# STERLING RANCH ROAD & BRIARGATE PARKWAY GESC

## COUNTY OF EL PASO, STATE OF COLORADO GRADING AND EROSION CONTROL PLANS DECEMBER 2021

EPC STORMWATER REVIEW COMMENTS  
IN ORANGE BOXES WITH BLACK TEXT

STERLING RANCH ROAD &  
BRIARGATE PARKWAY GESC  
GRADING AND EROSION  
CONTROL PLANS  
SHEET 3 OF 9  
JOB NO. 25188.03

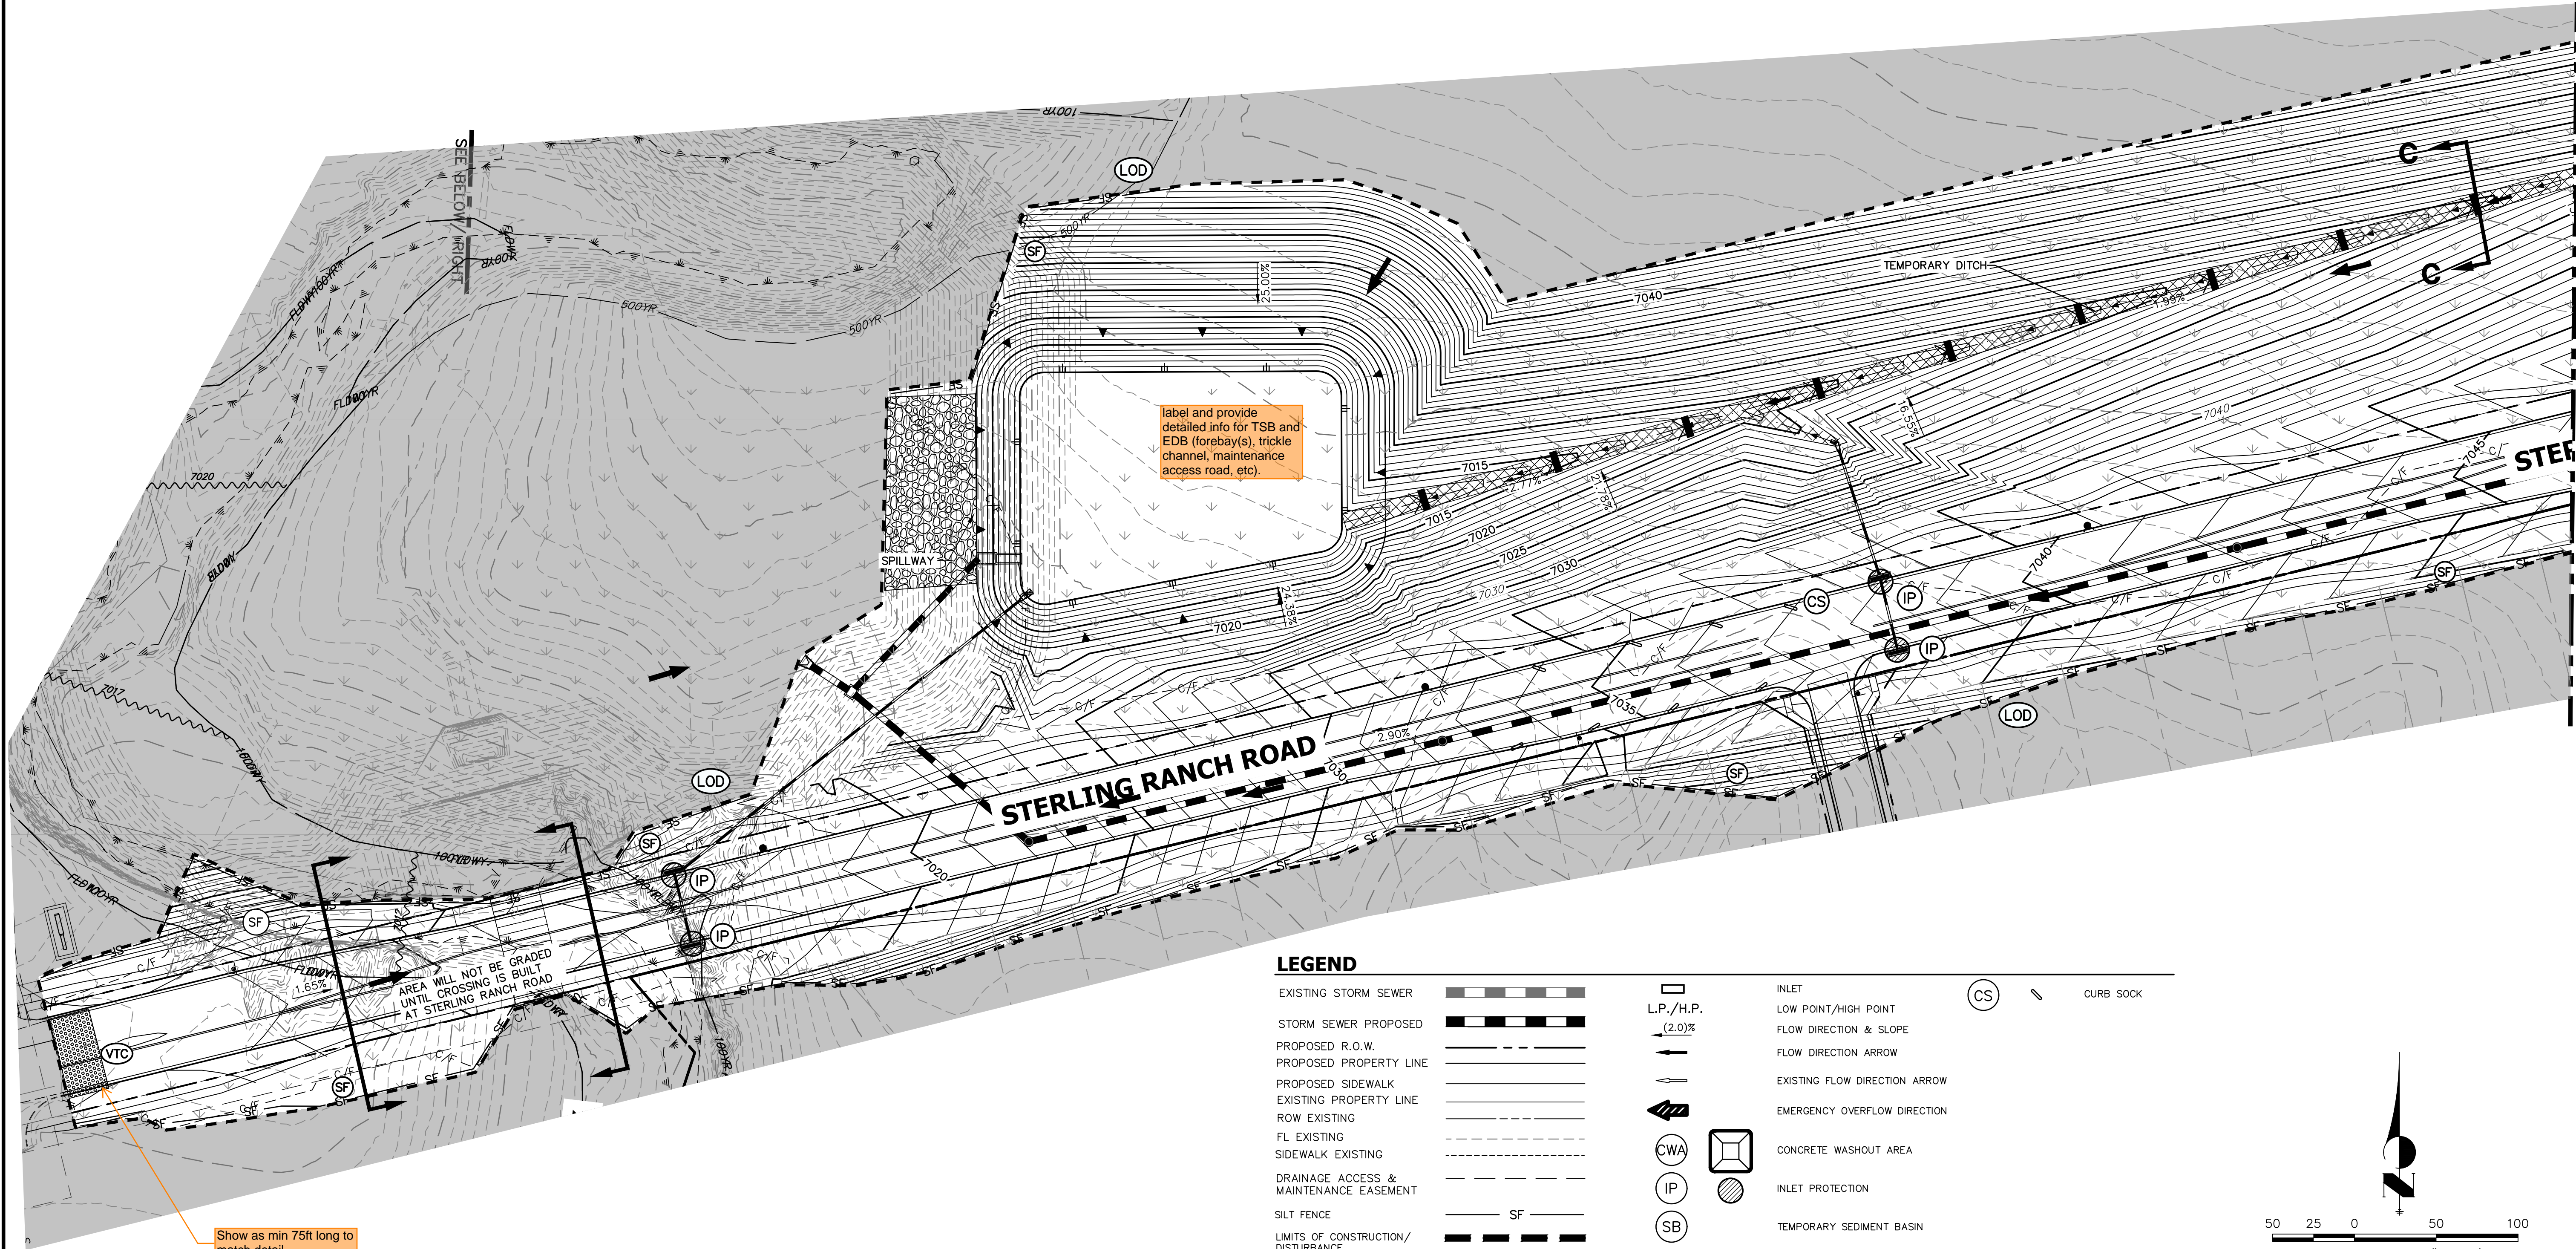
label and provide detailed info for TSB and EDB (forebay(s), trickle channel, maintenance access road, etc).

Show as min 75ft long to match detail.
